## DEVELOPMENT REVIEW COMMITTEE COMMENTS

### WRITTEN STATEMENT OF CONDITIONS

The City of North Richland Hills received this plat on March 8, 2023. The Development Review Committee reviewed this plat on March 21, 2023. The following represents the written statement of the conditions for conditional approval of the plat. The applicant may submit a written response and revised plat that adequately addresses each condition. See the **RESUBMITTAL REQUIREMENTS** section below for further information.

**A FINAL PLAT OF  
LOT 1  
THE WEST WINDS**

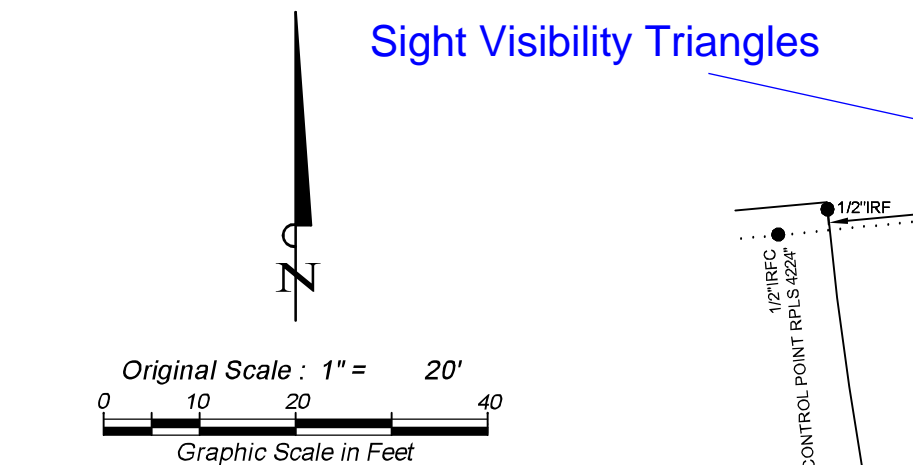
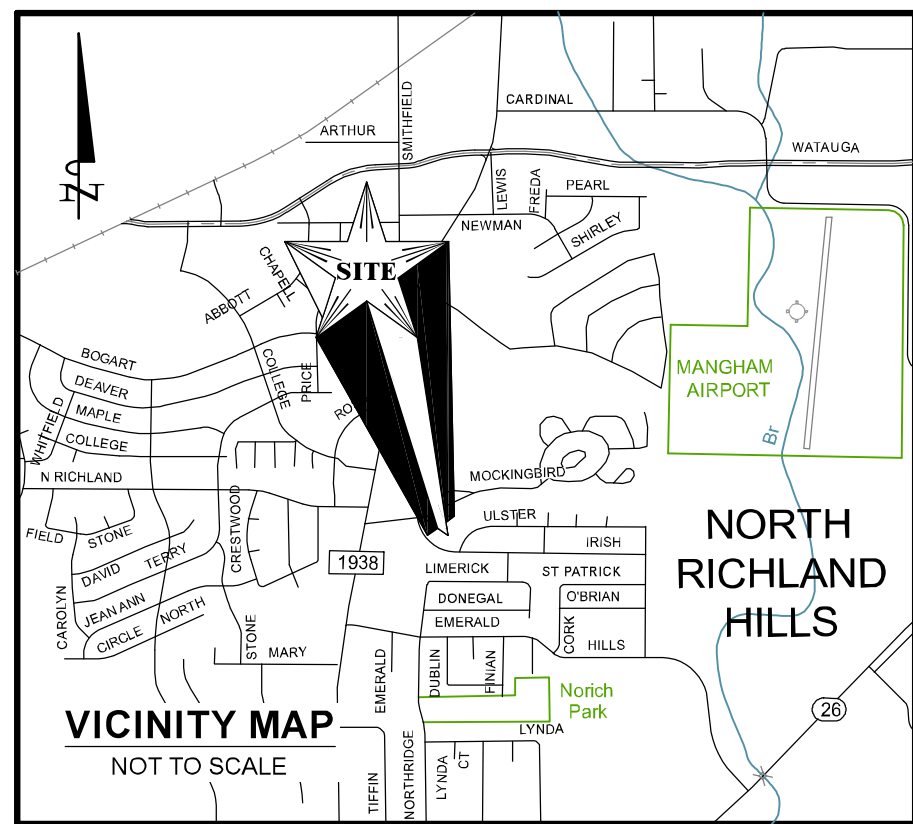
1. Change the legal description of the property to Lot 1, Block 5, Red Gate Addition. Update this reference on the drawing, title block, dedication statement, lots and other relevant instances as noted on the marked-up print. *NRH Subdivision Regulations §110-331 (Requirements for all plat drawings – subdivision name)*

2. The County clerk recording block may be removed from the drawing. Plats are recorded electronically, and the block is not necessary. *NRH Subdivision Regulations §110-333 (Additional requirements for plat drawings – county certification)*

3. Revise the label on the building lines adjacent to Mockingbird Lane and Irish Drive to read 20' building line. Extend these building lines to the east and south property lines. *NRH Subdivision Regulations §110-331 (Requirements for all plat drawings – building setback lines)*

4. Remove the side and rear building lines from the drawing. These lines are not required or recommended to be shown on the plat. *NRH Subdivision Regulations §110-331 (Requirements for all plat drawings – building setback lines)*

5. Add and label a sight visibility easement at the intersection of Mockingbird Lane and Irish Drive. The easement (triangle) is measured 15 feet perpendicular on Irish Drive from the intersection of the street right-of-way and 70 feet parallel to Mockingbird Lane. See the marked-up print for more information. *NRH Zoning Ordinance §118-714 (Visibility sight triangles)*

6. Add and label a sight visibility easement at the intersection of the south property line and the TESCO right-of-way. The easement (triangle) is measured 15 feet perpendicular from the intersection of the street right-of-way and the TESCO right-of-way and 70 feet parallel to Irish Drive. This easement is required to provide visibility of and for pedestrians using the North Electric Trail located in the TESCO right-of-way. See the marked-up print for more information. *NRH Zoning Ordinance §118-714 (Visibility sight triangles)*

7. Add a 10-foot by 10-foot corner clip right-of-way dedication or sidewalk and utility easement at the corner of Mockingbird Lane and Irish Drive. *NRH Subdivision Regulations Article XI Design Criteria §110-412 (Generally – corner clip)*

8. Public infrastructure improvements are required to support the development of the property. Maps indicate that there is not public sewer service for the property. The nearest public sewer is located at the manhole south of the apartment driveway south of the TESCO right-of-way on the west side of Irish Drive. A sanitary sewer main extension and manhole would be necessary to accommodate development of the lot. For questions concerning the sewer service, contact Nathan Frohman at 817-427-6410 or [nfrohman@nrhtx.com](mailto:nfrohman@nrhtx.com). *NRH Subdivision Regulations §110-451 (Proportionality determination) and §110-446 (Adequate public facilities)*

Whether it is Sight Visibility Triangles or some other method, need to ensure building and/or fence does not encroach on visibility for drivers coming south on Irish and pedestrians crossing Irish.

Depends on grading: Mockingbird is currently higher than the site. Therefore, from a drainage perspective, would make more sense for driveway to come off Irish.

10' x 10' corner clip ROW dedication or sidewalk/utility easement dedication

15' x 70' sight visibility easement

Revise to read: 20' building line

15' x 70' sight visibility easement

Remove side and rear building lines from drawing

Extend front building line to east property line

Maps indicate there is no Public sewer for this site. There is a private sewer for the mobile home park. Nearest Public Sewer is at MH south of apartment driveway (south of N. Electric Trail on West side of Irish). Would need to extend sewer main and add MH to accommodate.

Revise legal to: Lot 1, Block 5, Red Gate Addition

Add city case number: PLAT23-0038

Remove the County clerk recording block from the drawing. Plats are recorded electronically, and the block is not necessary.
